EXPLANATION OF SIGNIFICANT DIFFERENCES

ONONDAGA LAKE BOTTOM SUBSITE OF THE ONONDAGA LAKE SUPERFUND SITE

MODIFIED PROTECTIVE CAPS

March 2018

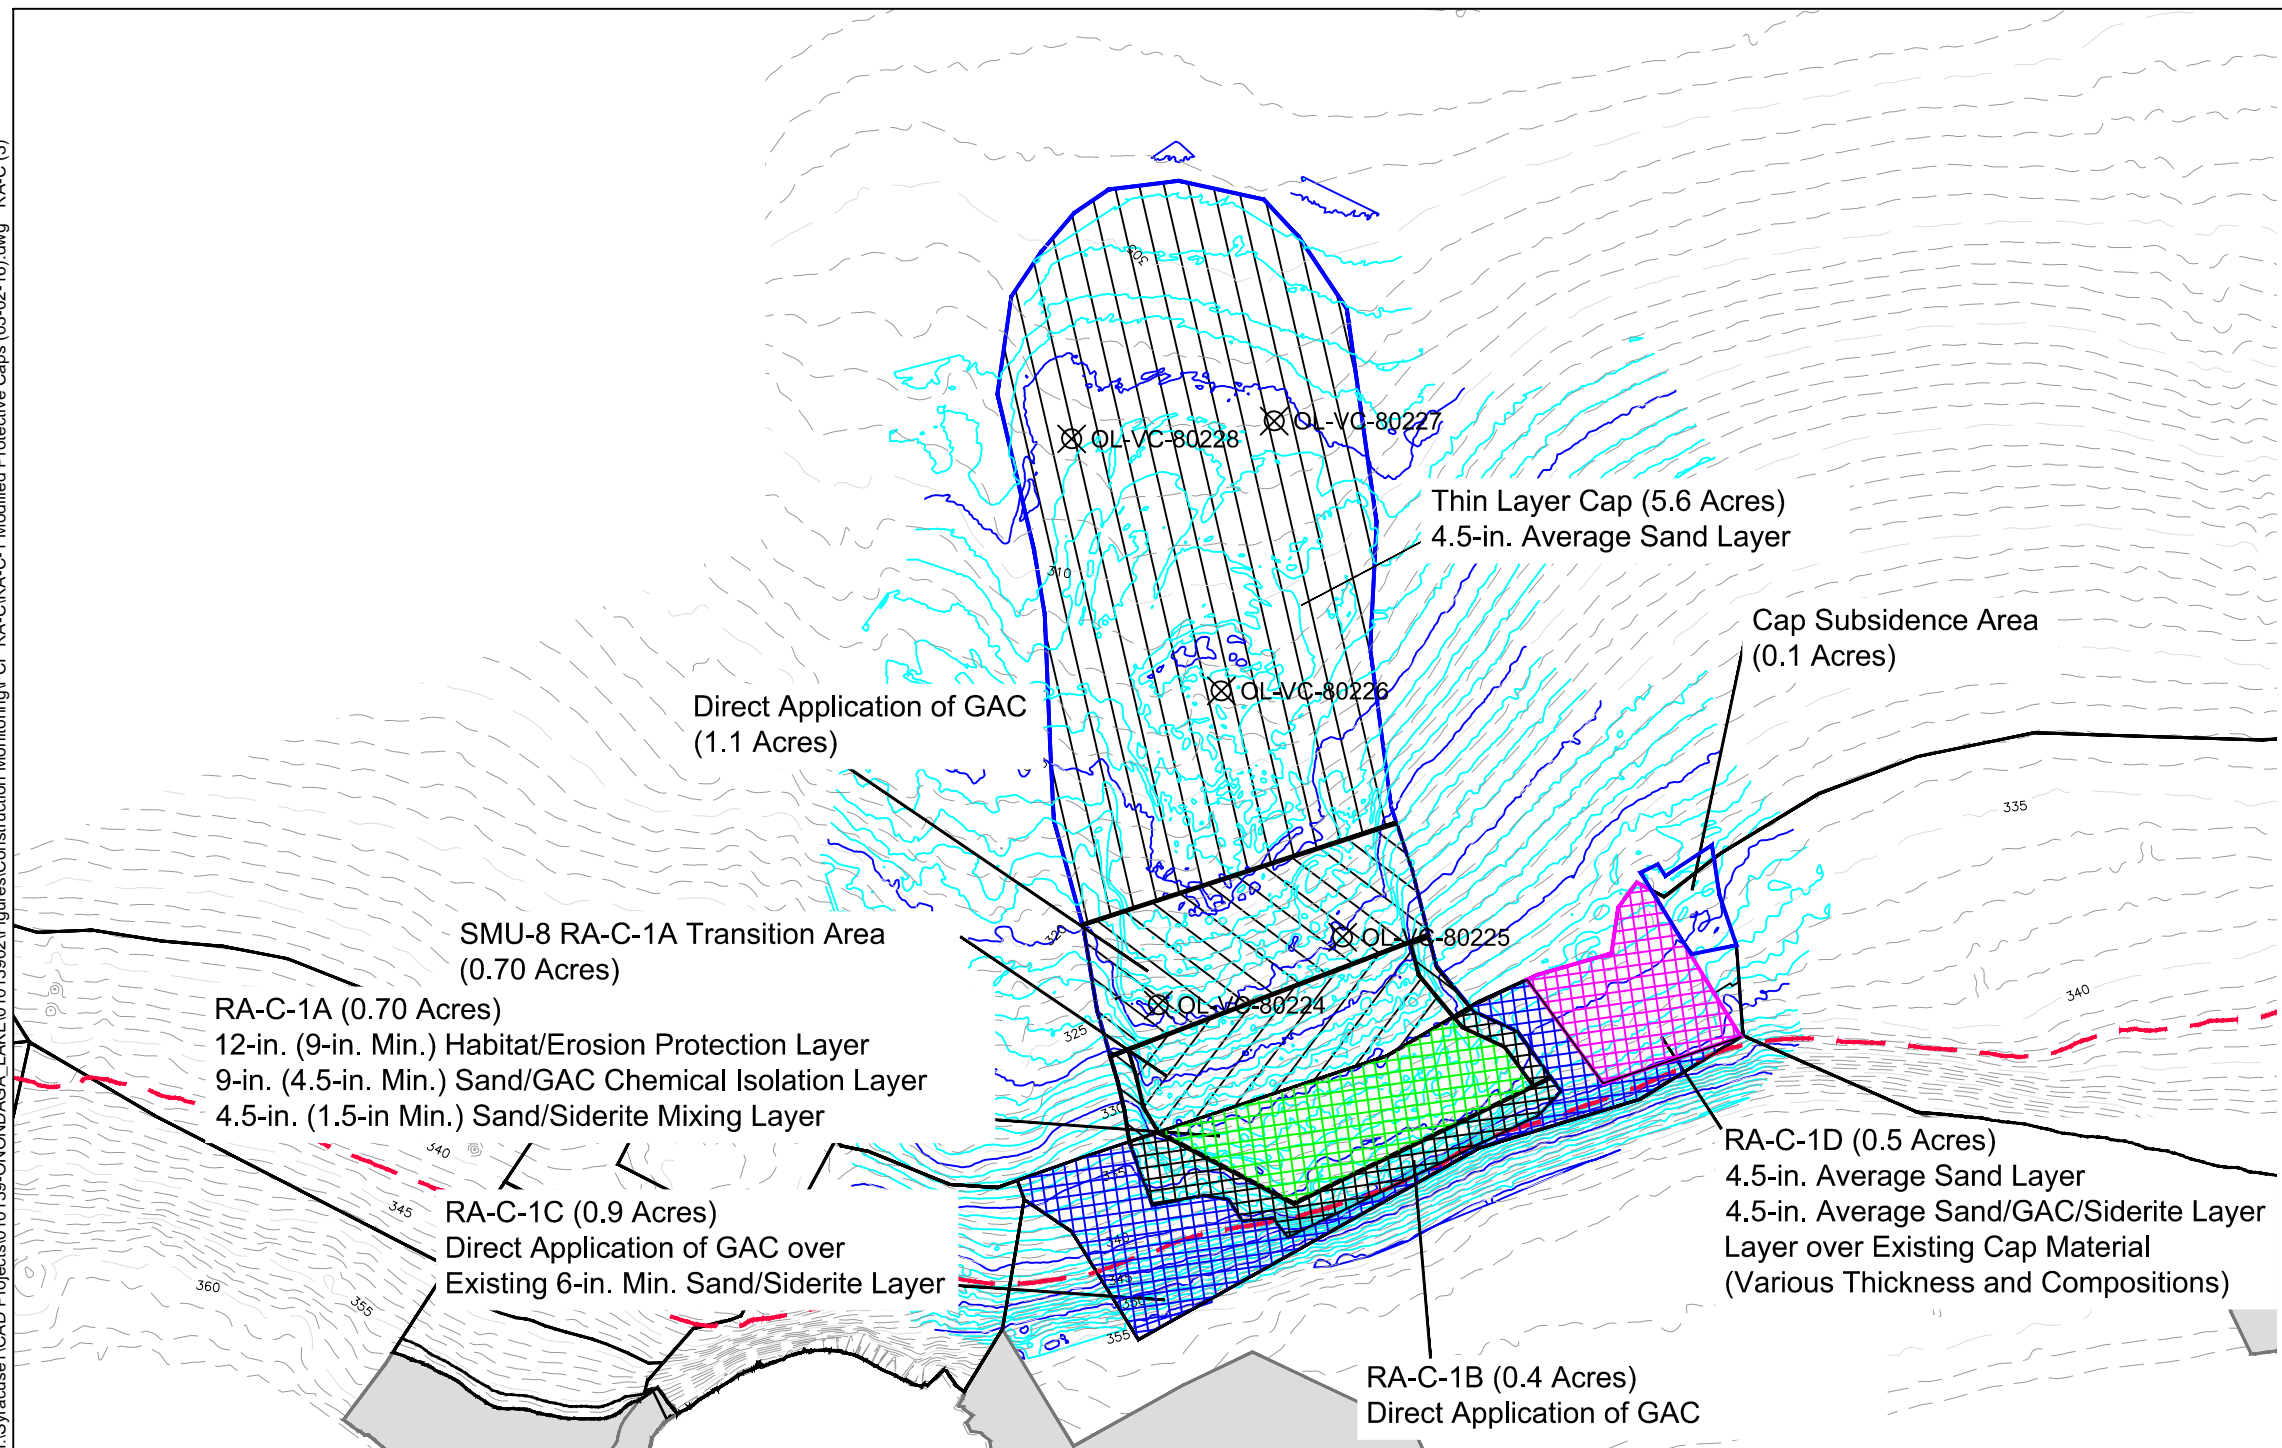
- **RA-C-1:** As shown in Figure 5 and presented in Table 1, approximately 0.7 acres of the total MPC area in the littoral zone in this subarea (2.5 acres) consist of a multi-layer cap with a minimum 9-inch habitat/erosion protection layer and a reduced thickness isolation layer (less than the minimum of 12 inches). An additional 0.5 acres consist of a mono-layer amended cap overlain by a thin layer of sand as well as 1.3 acres of direct application of GAC placed with a minimal amount of sand in areas where some cap material had been placed in 2012. Note that sand was mixed with GAC in the areas designated as direct application of GAC to facilitate GAC placement. As noted in Section 3.3, the cap disturbance in 2012 in RA-C impacted the adjacent SMU-8 area. Based on additional data and stability analyses, the MPC approach for the SMU-8 area adjacent to RA-C consists of 0.7 acres of mono-layer amended cap as a transition from the cap in the littoral zone, 1.1 acres of direct application of GAC with a minimal amount of sand, and 5.6 acres of thin-layer sand (unamended) cap (4.5-inch average thickness), for a total of 7.4 acres of cap material in SMU 8 in this area.

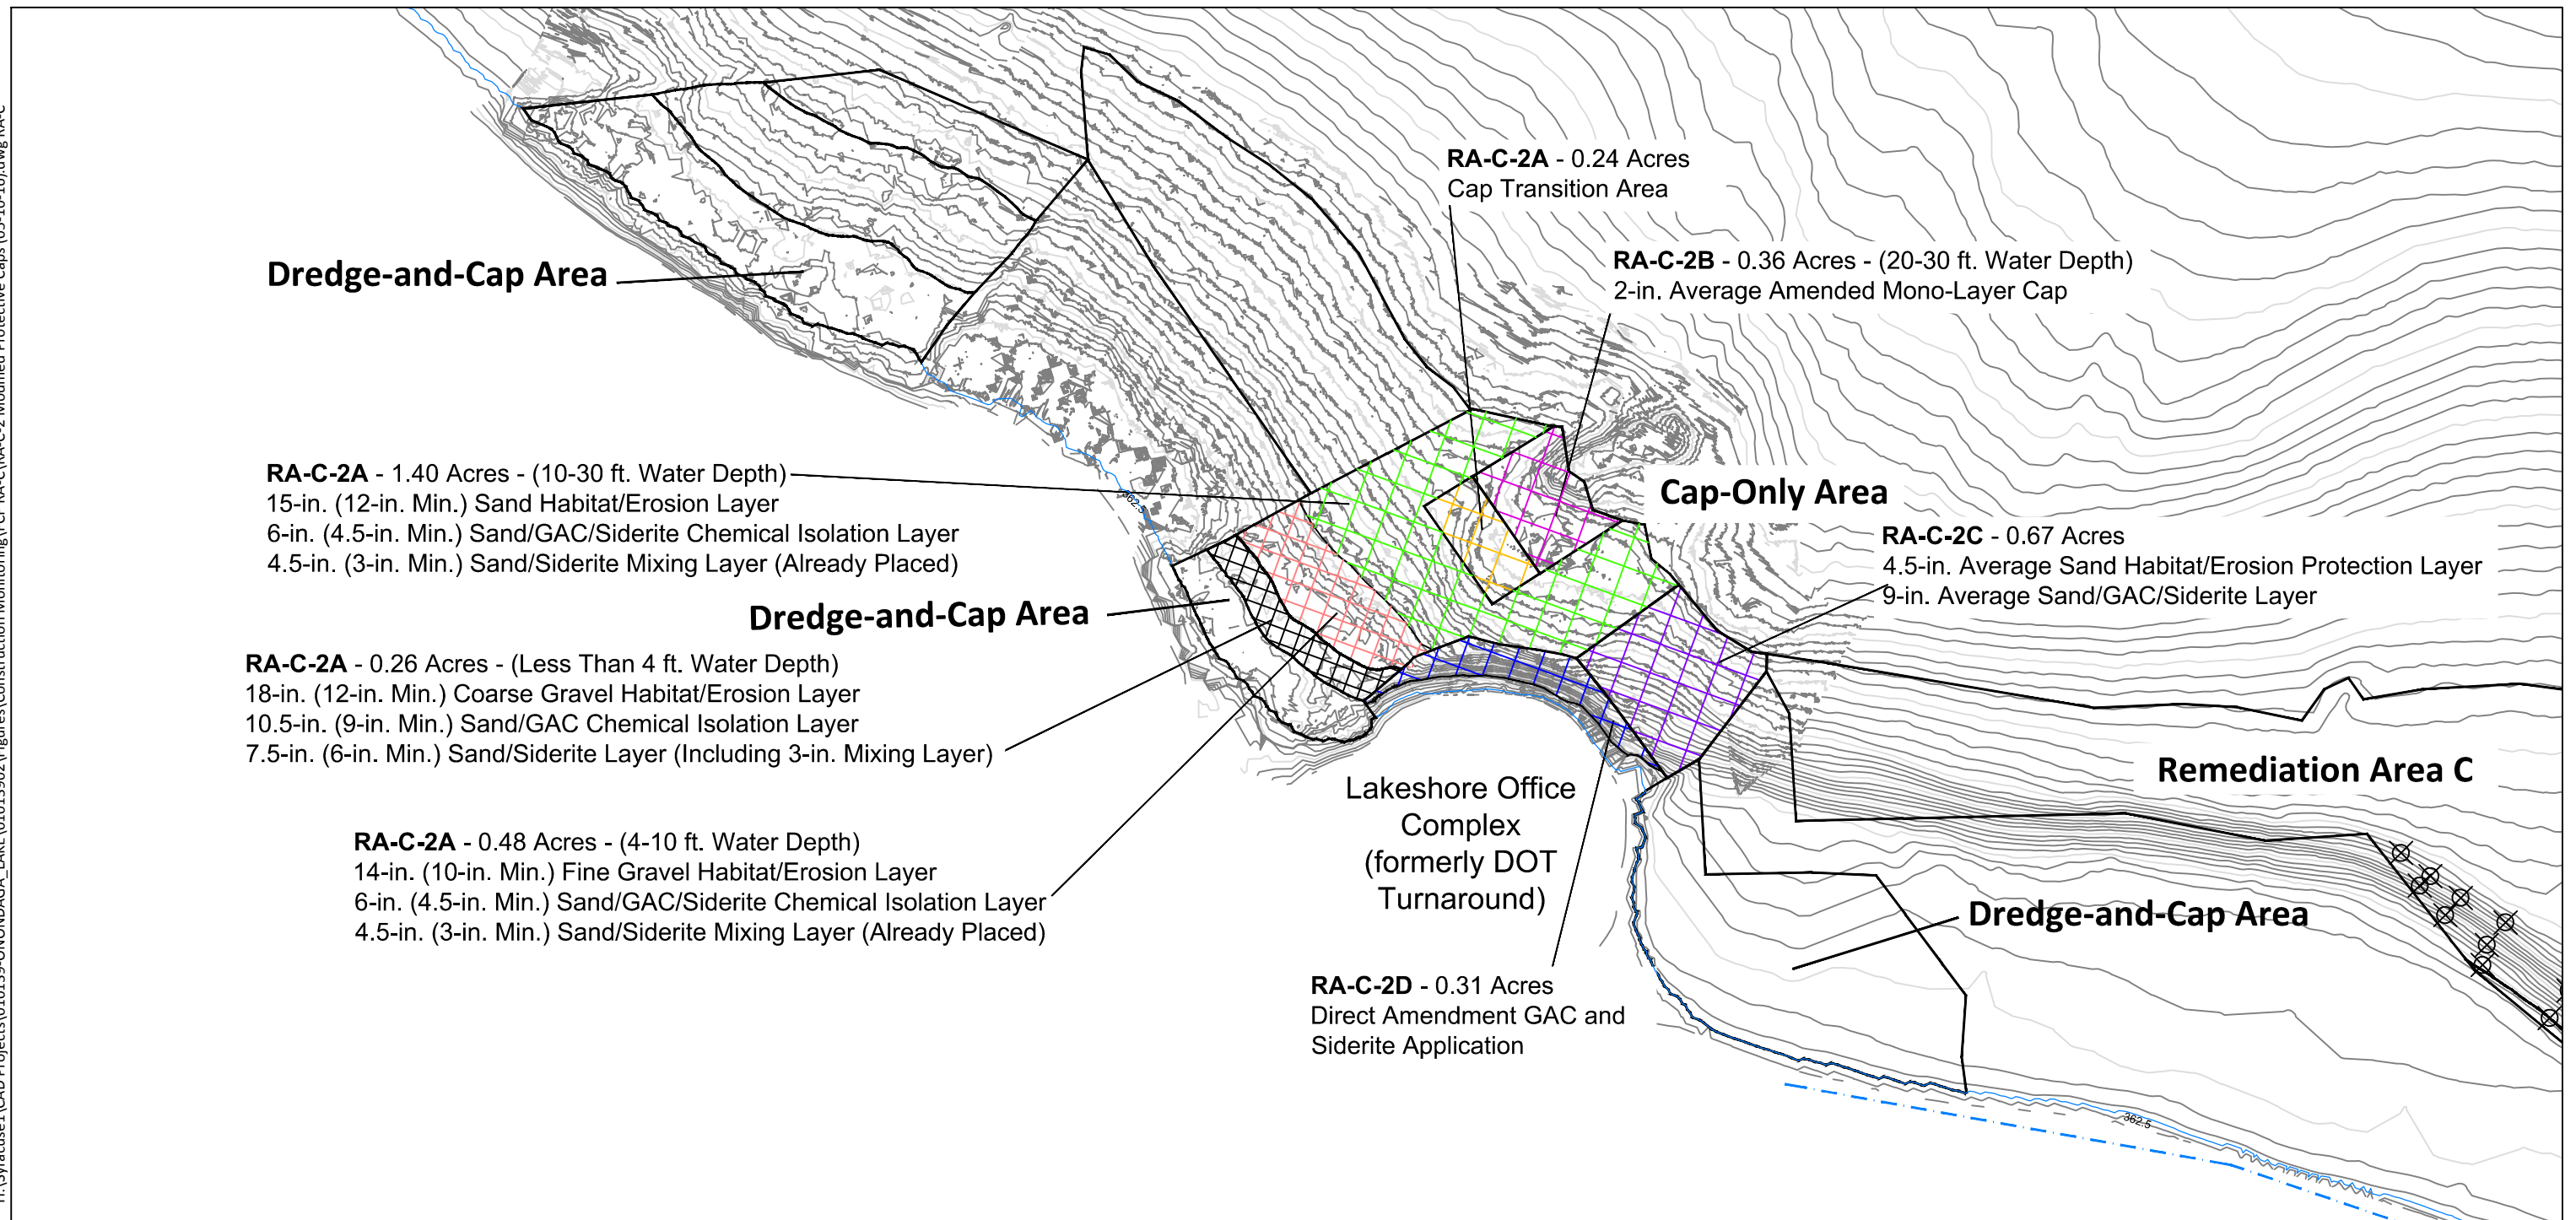
- **RA-C-2:** As shown in Figure 6 and presented in Table 1, approximately 1.7 acres of the total MPC area in this subarea (3.7 acres) consist of a multi-layer cap with a minimum 12-inch habitat/erosion protection layer; approximately 1.4 acres of the 1.7-acre area has a reduced thickness isolation layer as compared to the ROD mandated minimum of 12 inches.⁴ An additional 0.5 acres consist of a multi-layer cap with a minimum 10-inch habitat/erosion protection layer and a reduced thickness isolation layer (less than minimum of 12 inches). Approximately 0.6 acres consist of mono-layer amended caps of varying average thicknesses. An additional 0.7 acres consist of a mono-layer amended cap (average 9 inches) overlain by a thin layer of sand, as well as 0.3 acres of direct application of GAC/siderite placed with a minimal amount of sand in the near-shore area.

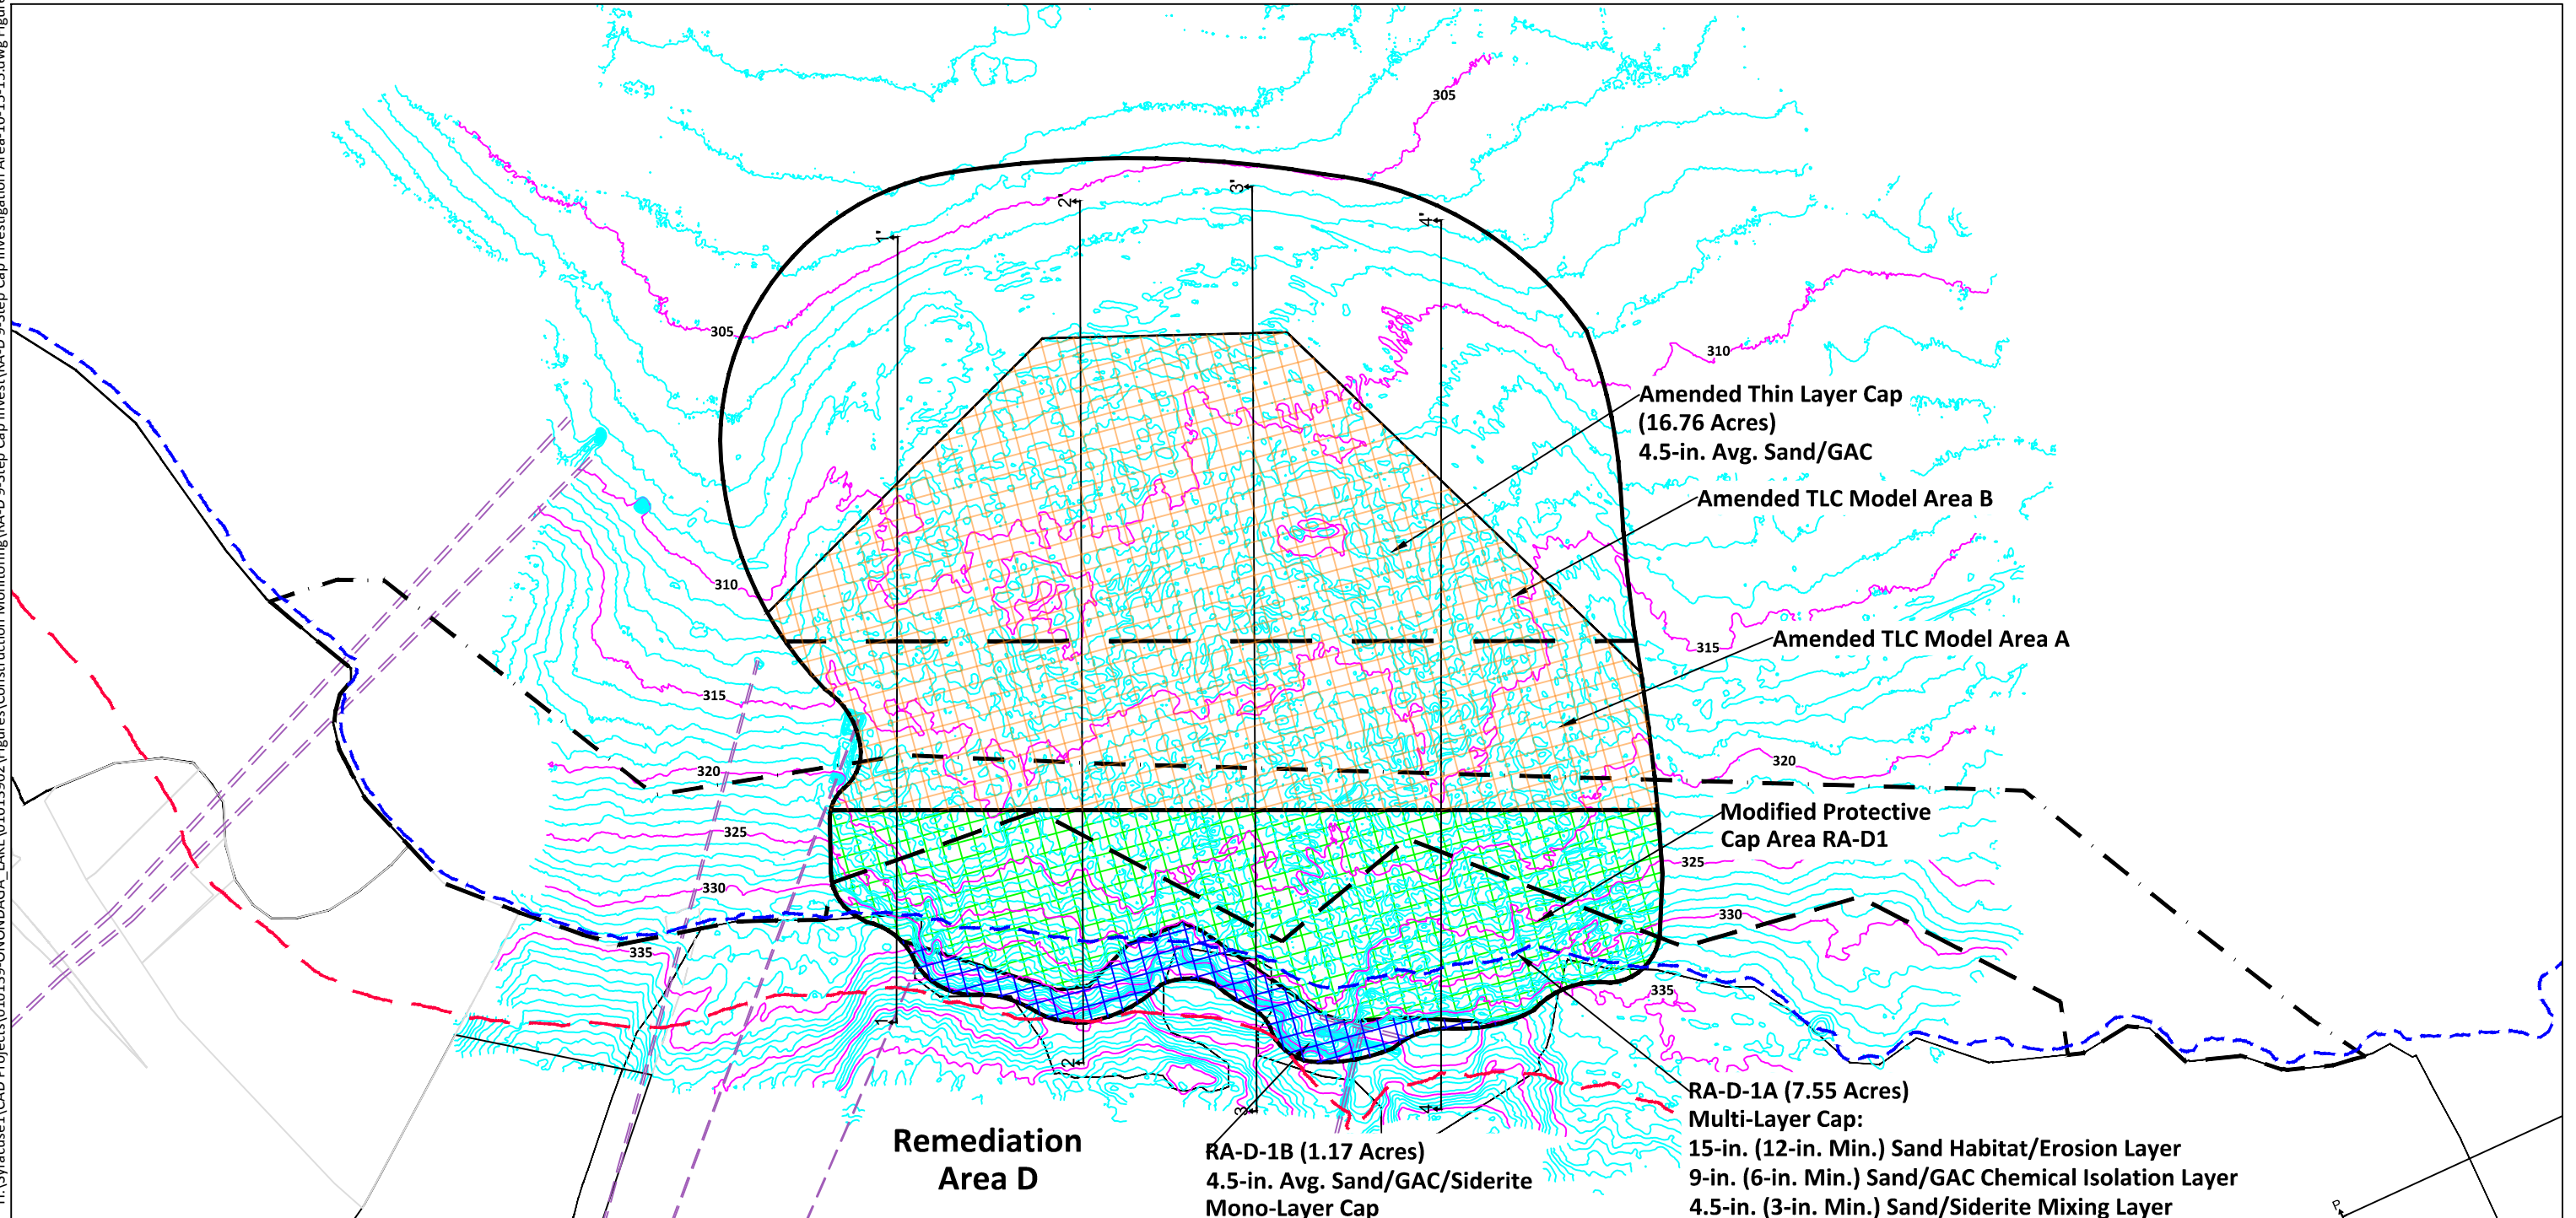
- **RA-D-1:** As shown in Figure 7 and presented in Table 1, approximately 7.6 acres of the total MPC area in the deep part of the littoral zone (identified as the “Addendum Area” in the Final Design) in this subarea (8.8 acres) include a multi-layer cap with a minimum 12-inch habitat/erosion protection layer and a reduced thickness isolation layer (less than minimum of 12 inches). An additional 1.2 acres, upgradient of this multi-layer cap at the location of the cap disturbance in 2014, consist of a mono-layer amended cap with an average thickness of 4.5 inches. As noted in Section 3.3, the cap disturbance in 2014 in RA-D impacted the adjacent SMU-8 area. Based on additional data and stability analyses, the MPC approach for the SMU-8 area adjacent to RA-D consists of 16.8 acres of mono-layer amended caps with a 4.5-inch average thickness with varying GAC dosages.
